ADDENDUM # 1

RFQ 7575502

**TITLE: Interior Renovations RIAG Building 150 South Main Street,
Providence**

This Addendum forms a part of the Contract Documents and modifies the Drawings and Project Manual as hereinafter indicated.

Project Number: 9999
Drawing No. E103
Sheet of

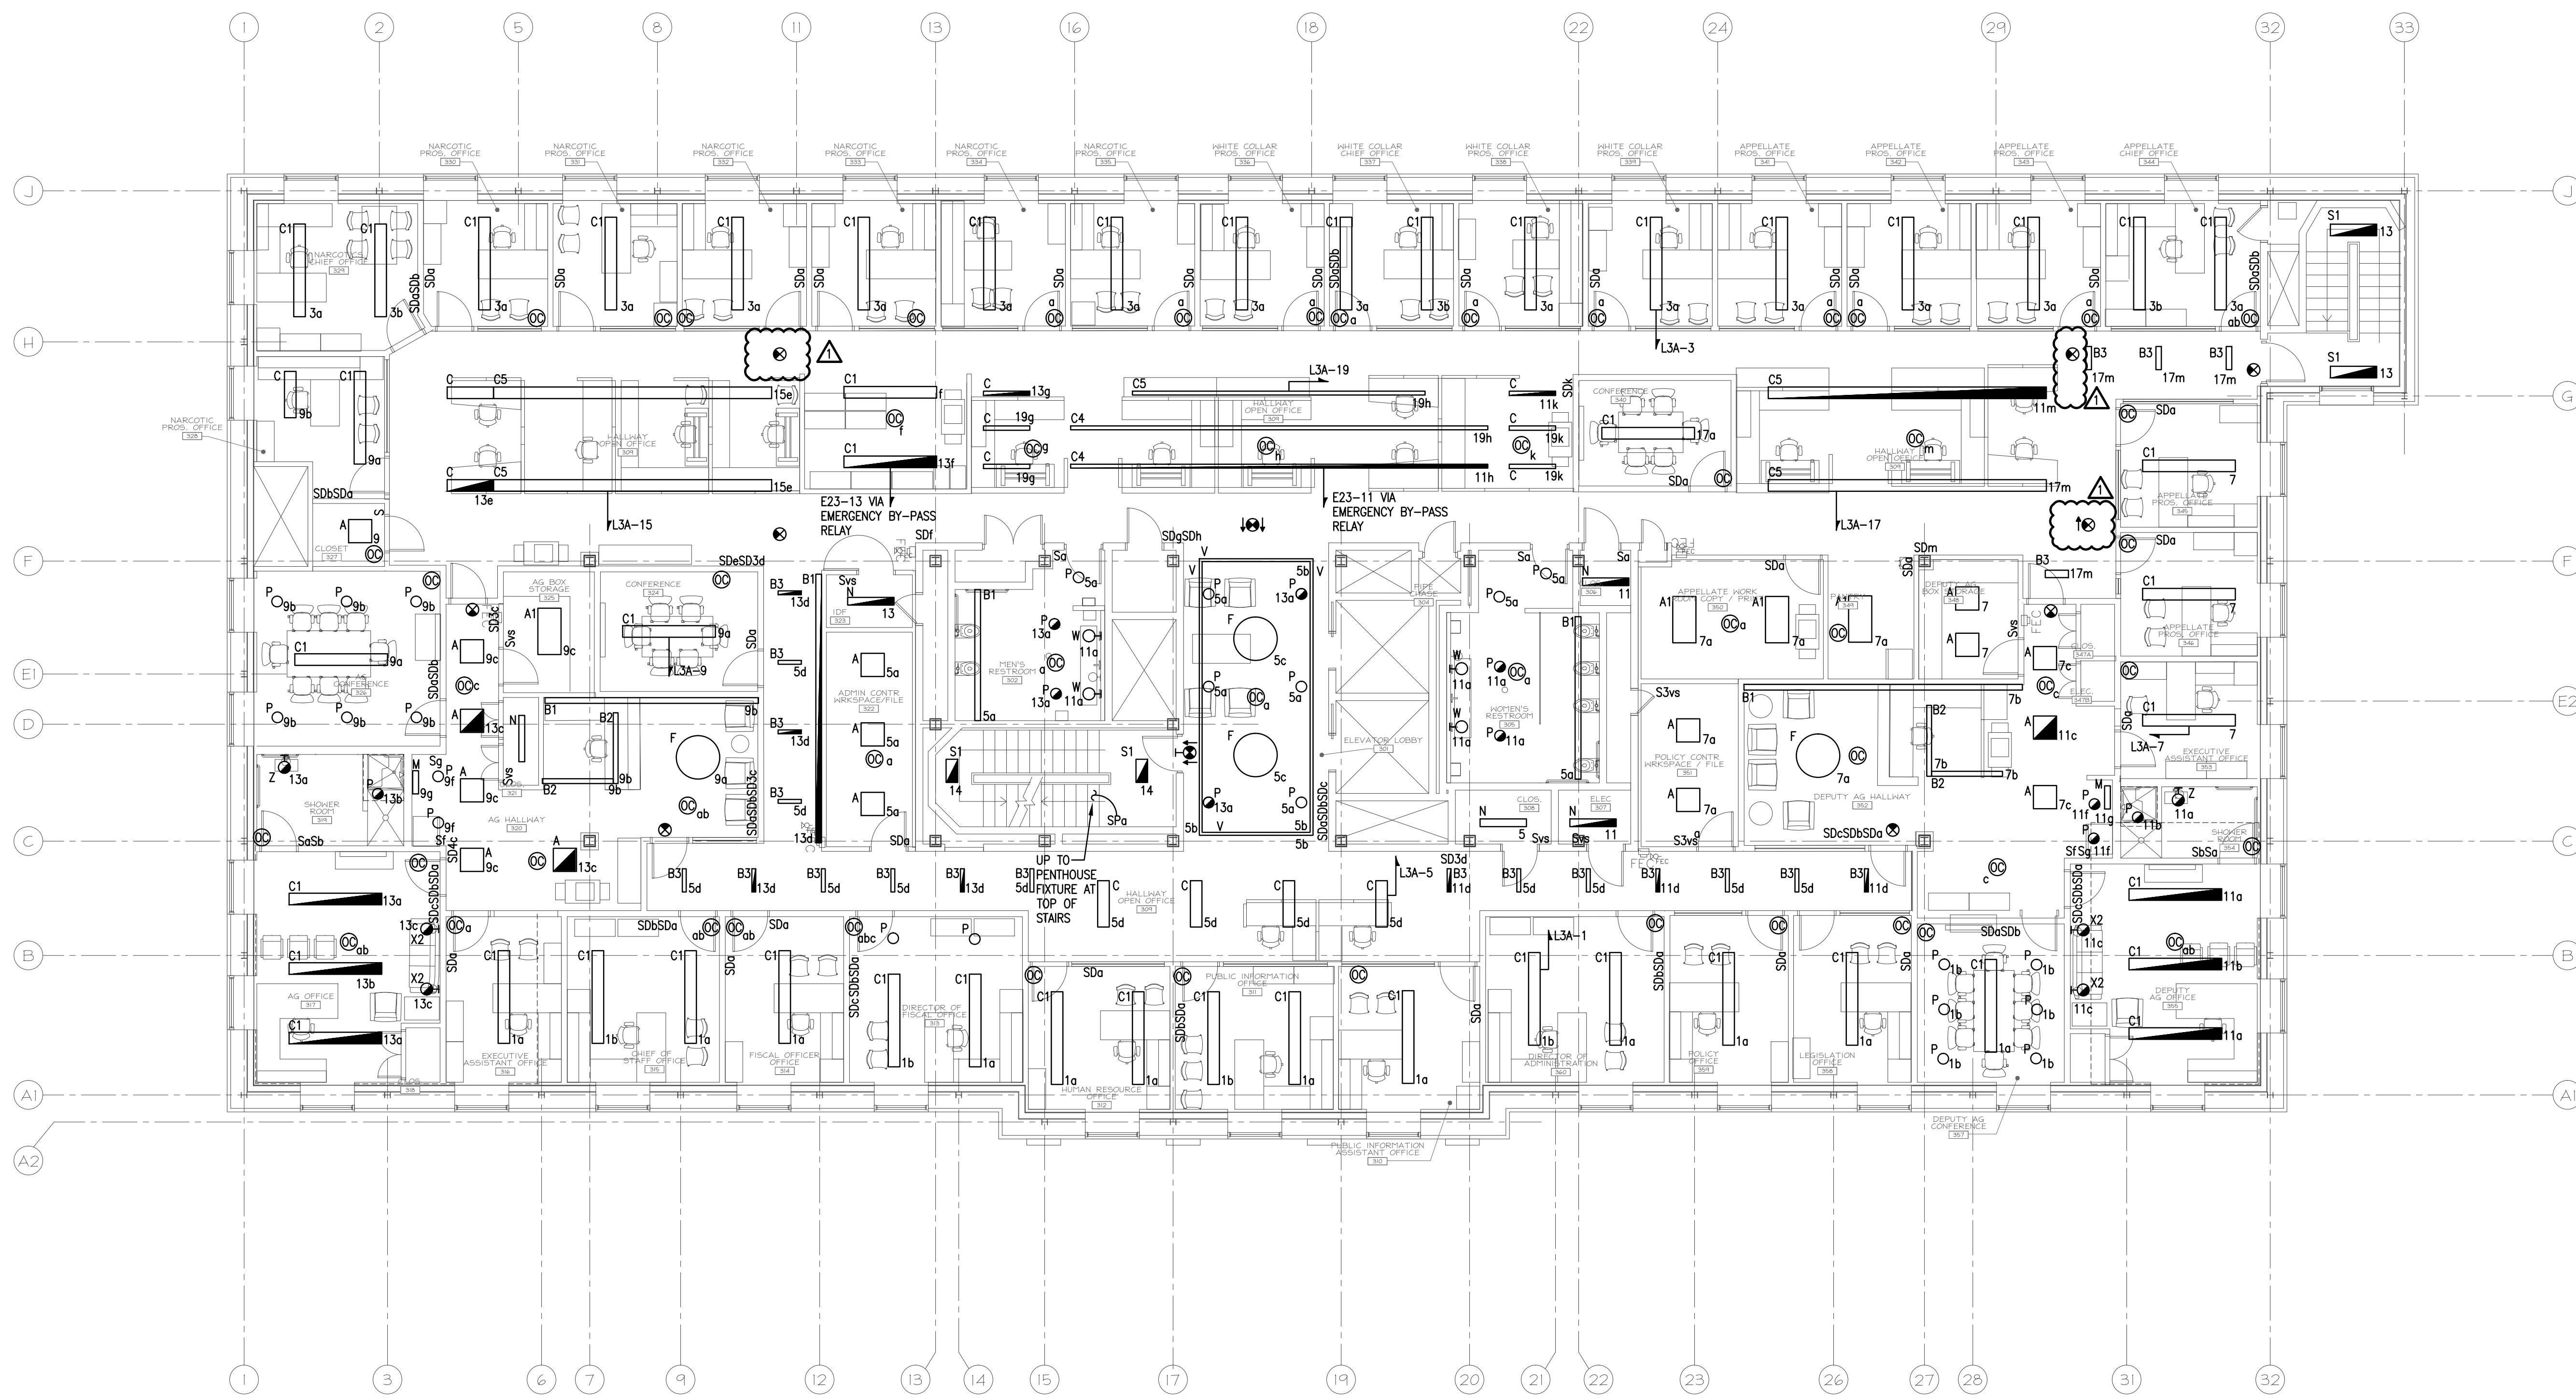
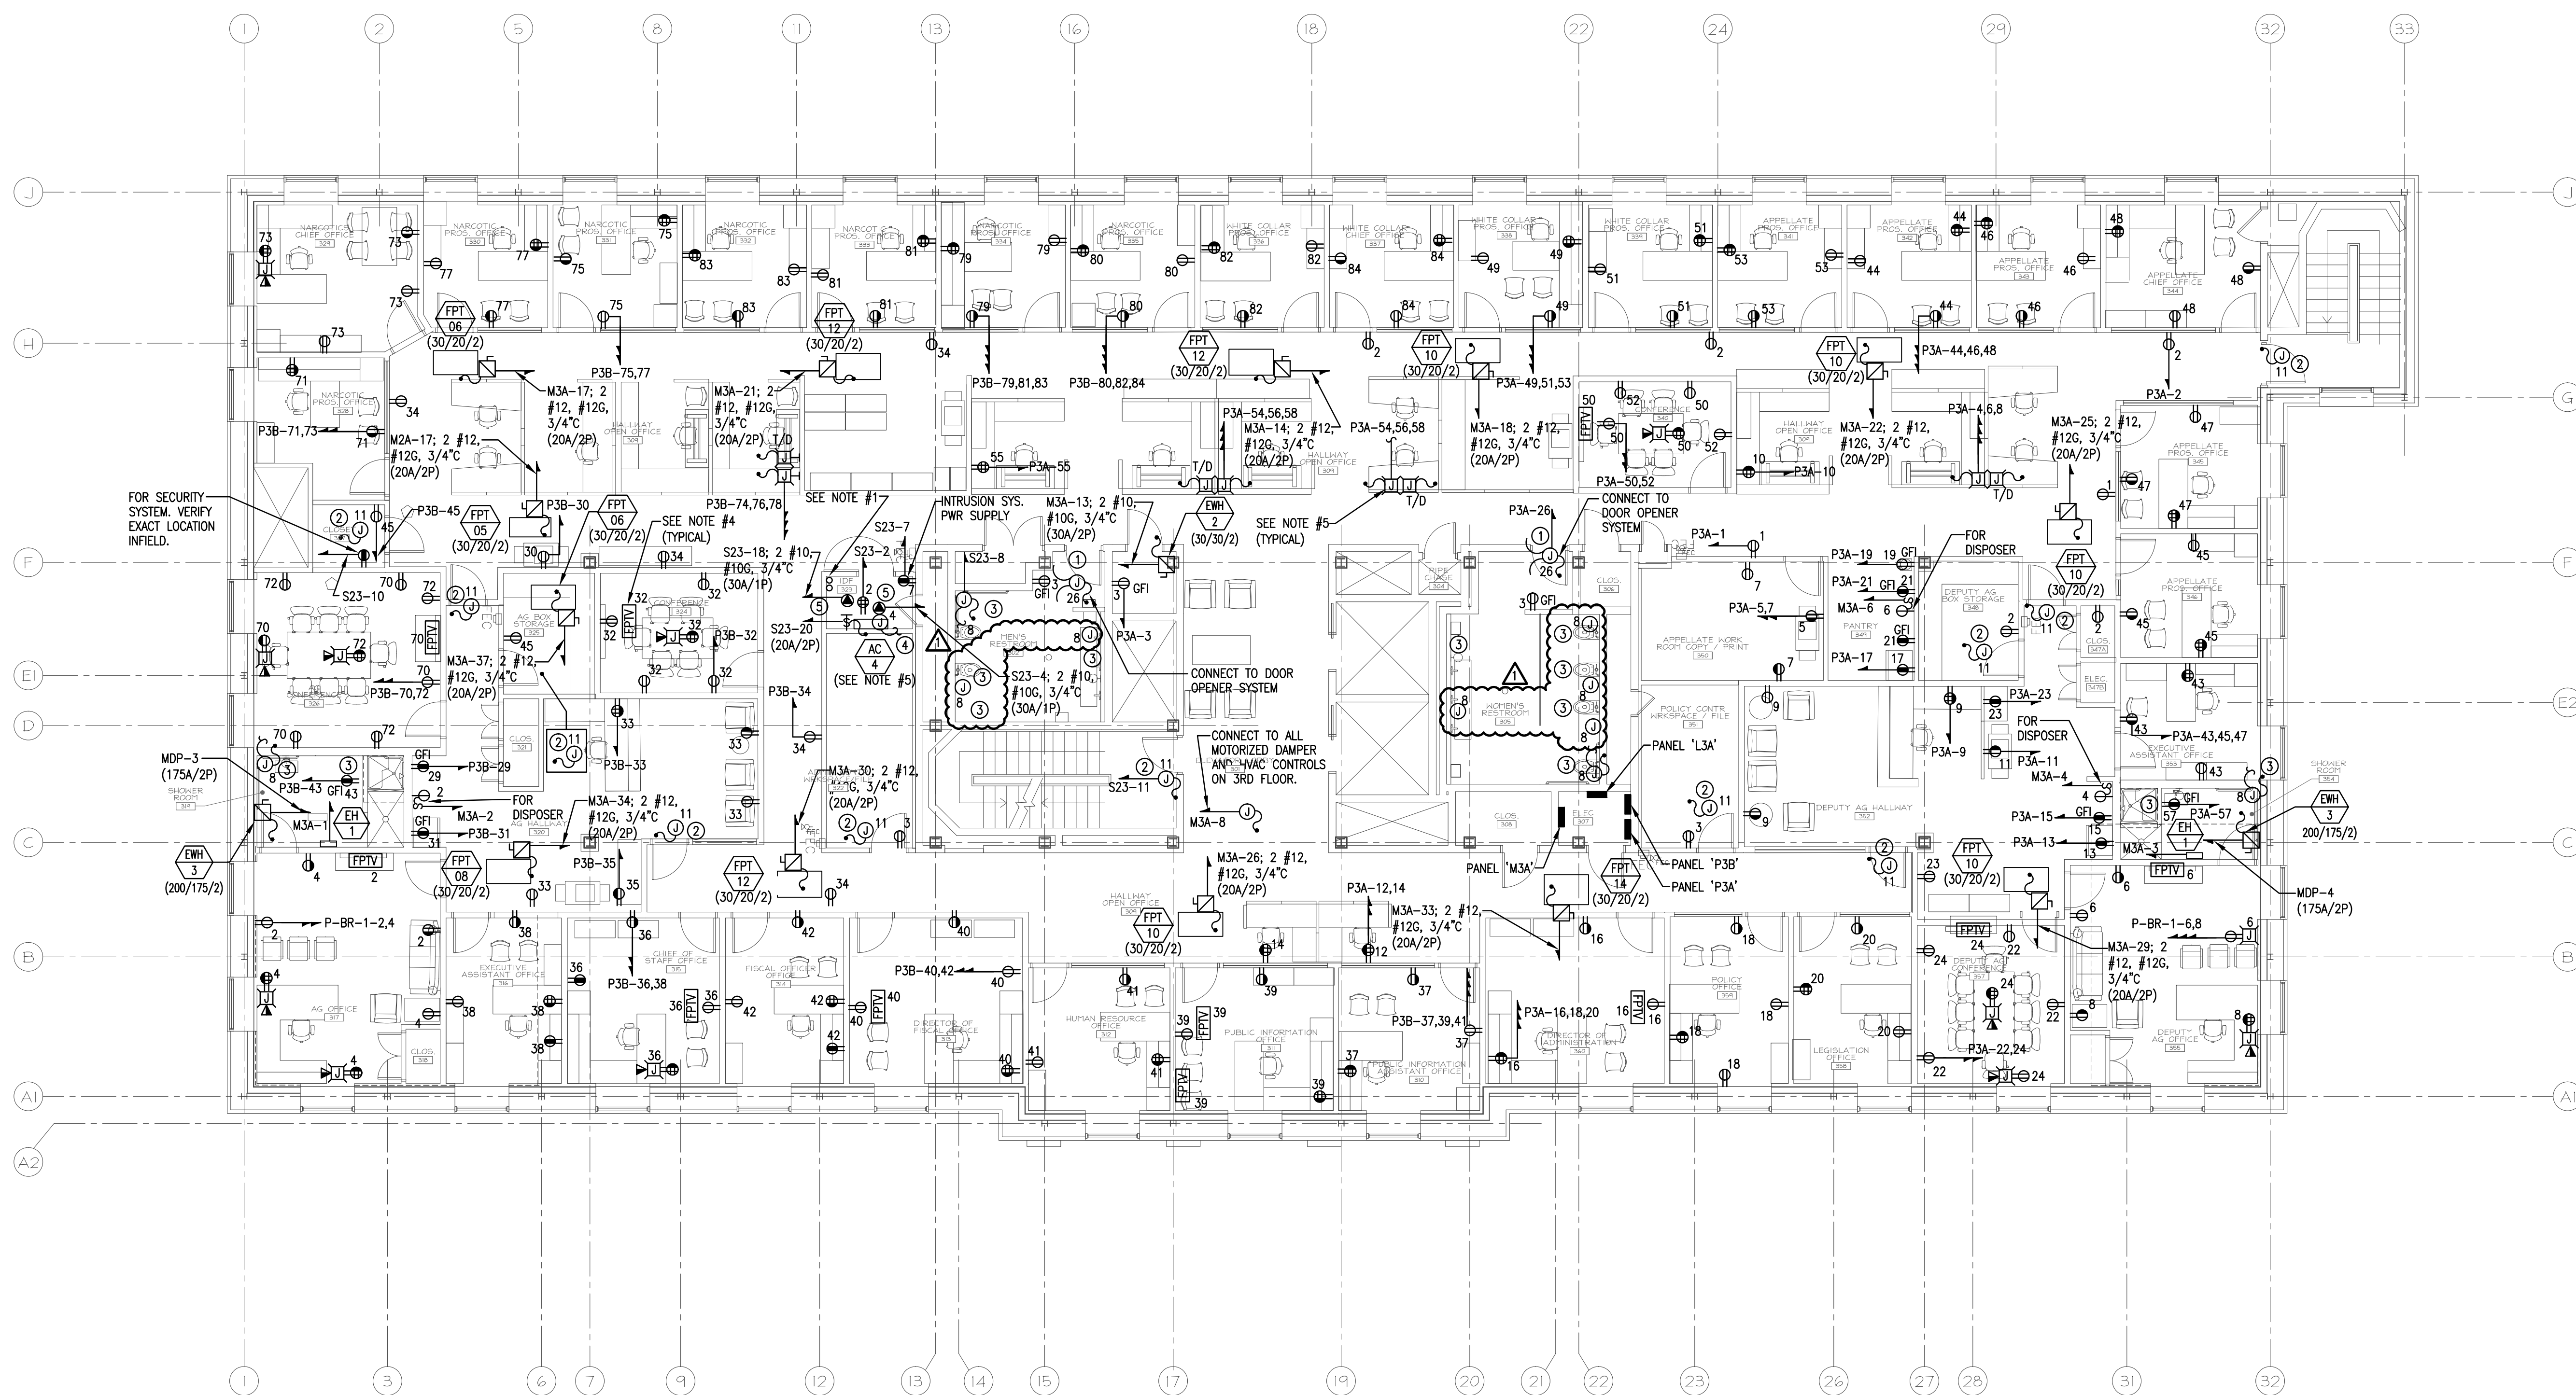
- C. Clarify office receptacle circuiting.
7. Drawing #E102:
 - A. Add exit lighting.
 - B. Clarify toilet room flush valve power.
8. Drawing #E103:
 - A. Add exit lighting.

- B. Clarify toilet room flush valve power.
9. Drawing #E104:
 - A. Relocate new penthouse switchboard and revise rating.
 - B. Indicate individual feeders from penthouse switchboard to each elevator.
